SERVICE BULLETIN

DRIVELINE/
REFERENCE DIFFERENTIAL
NUMBER 003
DATE 02-12-88
MODEL (MA), (MX), (RA)

CHANGE IN DIFFERENTIAL COVER GASKET MATERIAL

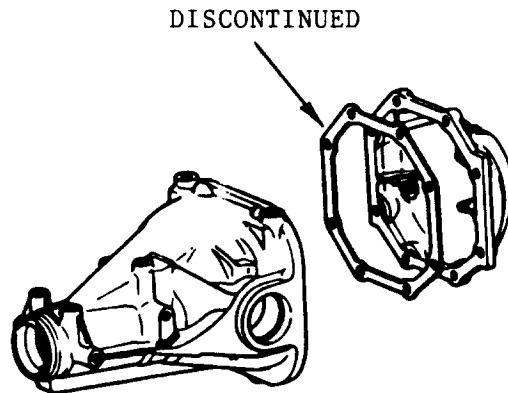
The gasket material used for 7.5" differential cover gaskets on Supra (MA67), Cressida (MX63, 73) and Celica (RA65) has been changed from a conventional paper-type to formed-in-place-gasket-type (FIPG).

The previous paper-type gasket has been discontinued as a replacement part.
